# Work Order ID 85370

Item Name: Crosstube Aft

DRAWING NO. D412-664-243	TITLE CROSSTUBE ASSEMBLY (412 HI AFT)	REV. E	DART AEROSPACE LTD ENGINEERING ORDER		D.E.O. NO. D412-664-243-E-1	SHEET NO. SHEET 1 OF 2	SCALE NTS
DRAWN	CHECKED <i>MP</i>	MFG. APPR. <i>E</i>	APPROVED <i>MP</i>	DE APPR. <i>H</i>			
DATE 11.03.31	DATE 11/03/31	DATE 11.03.31	DATE 11/03/31	DATE 11-03-31

DRAWING NO. D412-664-243	TITLE CROSSTUBE ASS'Y (412 HI AFT)	REV. E	DART AEROSPACE LTD ENGINEERING ORDER		D.E.O. NO. D412-664-243-E-2	SHEET NO. SHEET 1 OF 1	SCALE NTS
DRAWN 97	CHECKED ASS	MFG. APPR. E	APPROVED MP		DE APPR. H		
DATE 11.09.07	DATE 11.09.19	DATE 11.09.19	DATE 11.09.19		DATE 11.09.19

DRAWING NO. D412-664-243	TITLE CROSSTUBE ASSEMBLY (412 HI AFT)	REV. E	DART AEROSPACE LTD ENGINEERING ORDER	D.E.O. NO. D412-664-243-E-1	SHEET NO. SHEET 2 OF 2	SCALE NTS
DRAWN	CHECKED	MFG. APPR.	APPROVED	DE APPR.		
DATE 11.03.31	DATE 11.03.31	DATE 11.03.31	DATE 11.03.31	DATE 11.03.31

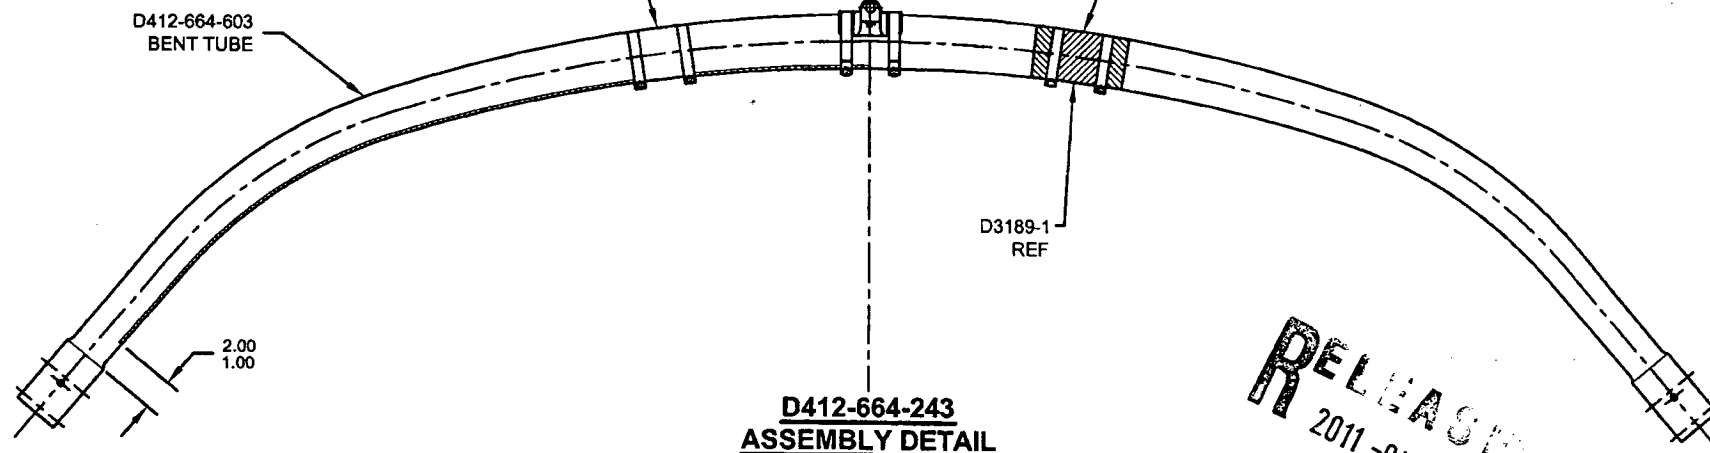
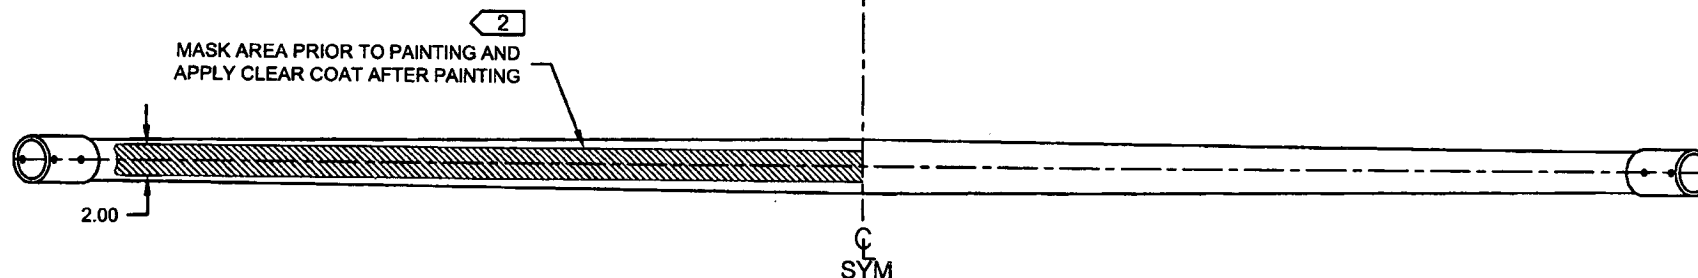
**PURPOSE:**

REMOVED ABRASION STRIP IN FAVOR OF A THIN LAYER OF PROSEAL 890.

**IS:**

D3189-1 CHAFING SHIELD (1, INSTALLED OVER PROSEAL 890)  
MS21920-28 CLAMP, 2X  
2 PL

**WAS:**

D2856-600-1009 ABRASION STRIP  
D3189-1 CHAFING SHIELD (1, INSTALLED OVER ABRASION STRIP)  
MS21920-28 CLAMP, 2X  
2 PL

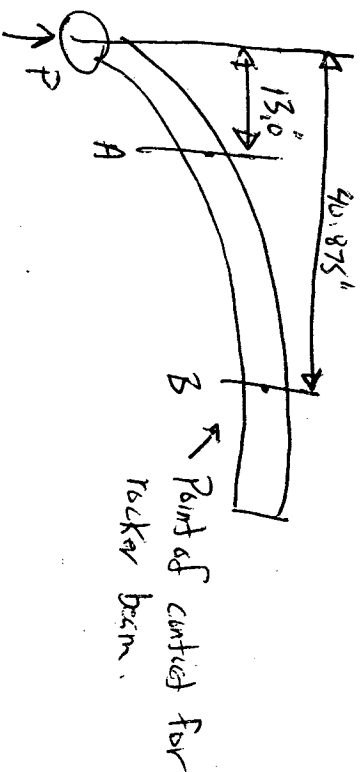
**PURPOSE:**

REPLACE MAGNOBOND WITH 3M DP460 SCOTCH-WELD EPOXY ADHESIVE

NOTE 12 & 16, SHEET 1 IS AMENDED AS FOLLOWS:

IS:

- 12) INSTALL D2896-1 CENTER SUPPORT USING A 0.04" TO 0.07" THICK LAYER OF SCOTCH-WELD DP460 PER QSI 015. LET CURE FOR 24 HOURS AFTER INSTALLATION AND PRIOR TO PACKAGING.
- 16) TORQUE CLAMPS 80 TO 100 IN-LB. ENSURE AT LEAST 1.5 THREADS SHOWING IN SAFETY AND THAT NUT HAS NOT BOTTOMED-OUT AFTER TORQUING. **PRIOR TO PACKAGING, RE-CHECK TORQUE ON CLAMPS AFTER ADHESIVE HAS CURED FOR 24 HOURS.**
